Subject: Final Little City Building Ottawa Findings Report
EPA Contract No. EP-S5-13-01
Technical Direction Document No. S05-0001-1501-001
Document Tracking No. 0146

**FINAL FINDINGS REPORT
FOR THE
LITTLE CITY BUILDING SITE
OTTAWA, MARION COUNTY, ILLINOIS**

Photo #3
Collapsed bay, full height of building

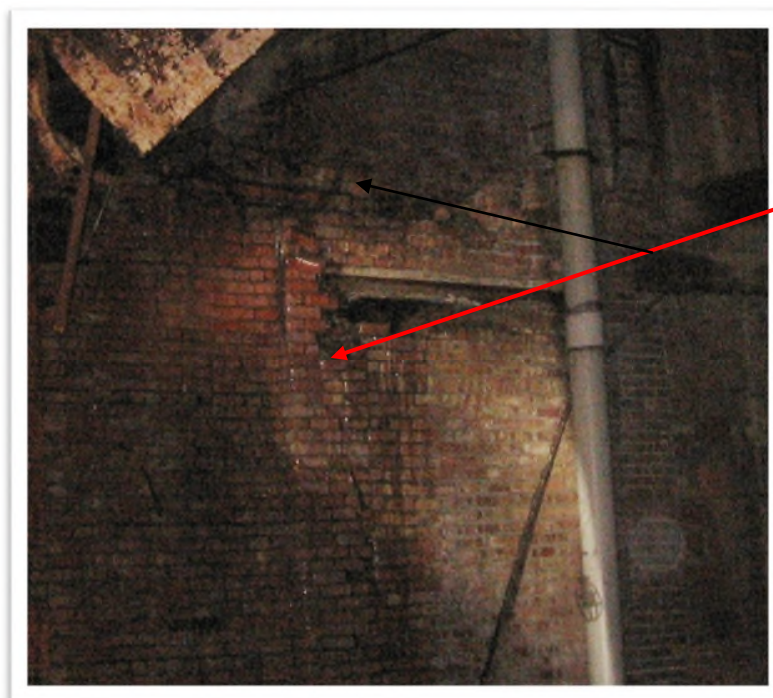
One item noticed by Tetra Tech and also mentioned by city officials in a meeting prior to the site visit was that the exterior wall that abuts the collapsed bay was damaged when presumably the bay collapsed. This was not mentioned in the Fehr Graham letter. Based on the limited visual inspection it was apparent that several wythes (layers) of brick had peeled away from the wall leaving the wall thinner than originally constructed. Furthermore, when viewed closer from the exterior side of the wall, vertical cracking was evident at this location along with loose mortar and brick debris on the ground. City officials have been visually monitoring the wall since the Fehr Graham letter and indicated during our site review that the wall cracks and debris on the ground were new and the wall looked to be in worse condition (Photos #5 and #6).

Photo #4
Missing wall bricks and ice along wall face

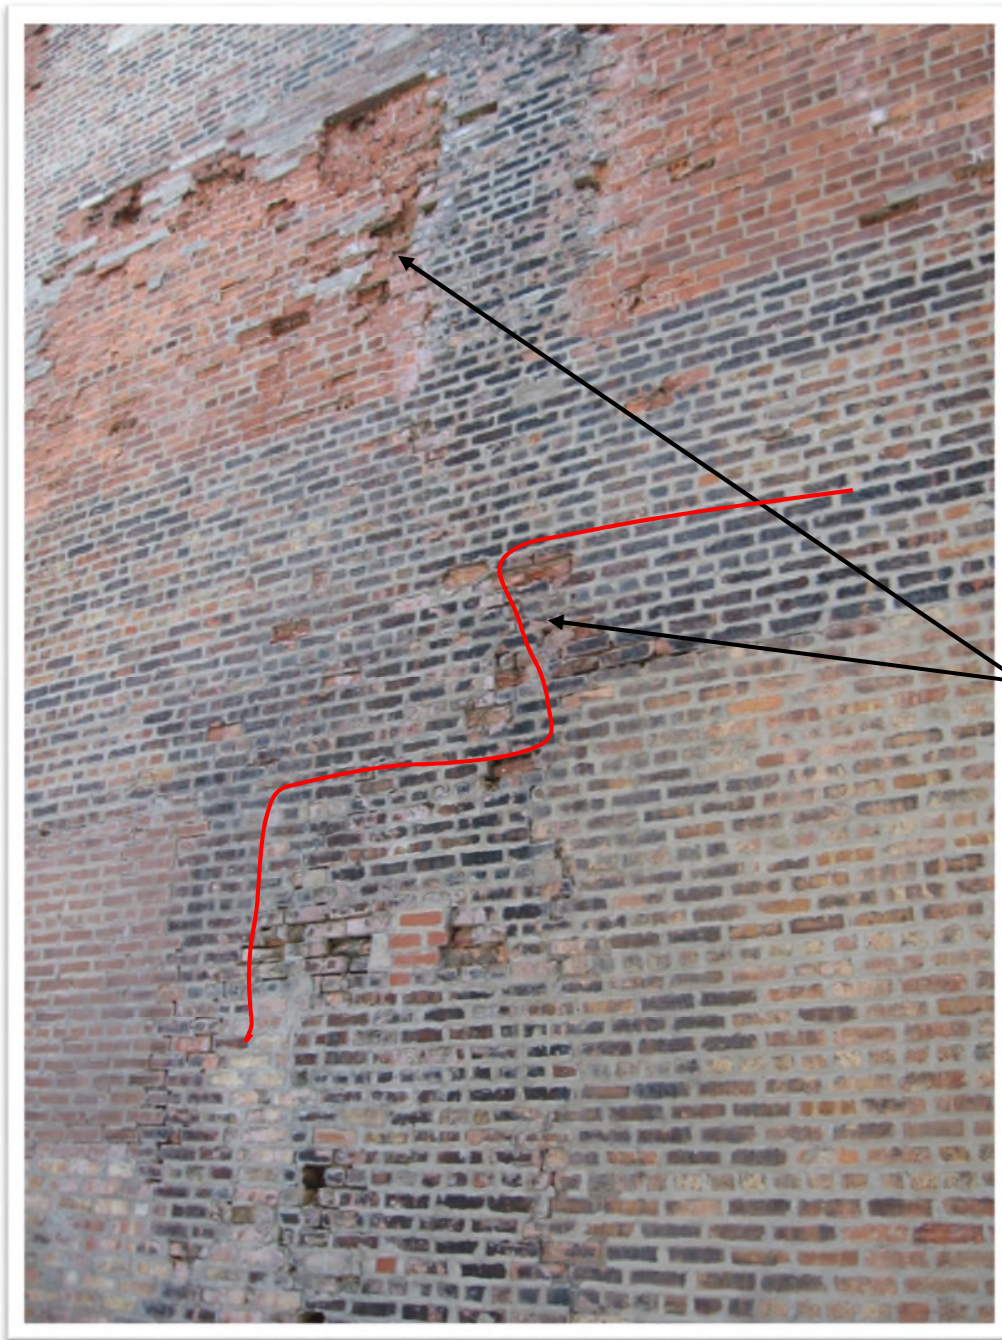
On January 28, 2015, a site visit was made by EPA OSC Brad Benning, Tetra Tech START, and officials from the City of Ottawa: Michael Sutfin and David Noble. Having knowledge of the unsafe building conditions presented in the findings of the Fehr Graham letter, a limited interior building entry was conducted. The first floor was accessed through the main entrance on the south face of the building. Tetra Tech only entered within the first 40 feet of the building which was enough to visually confirm some of the major findings outlined in the Fehr Graham letter: one bay of framing had collapsed from the fifth floor to the basement level (Photo #3); and water infiltration was prevalent as witnessed by the sagging plaster ceilings, mold, a sheet of ice along the exterior wall that abuts the collapsed bay, and water staining throughout. (Photo #4).
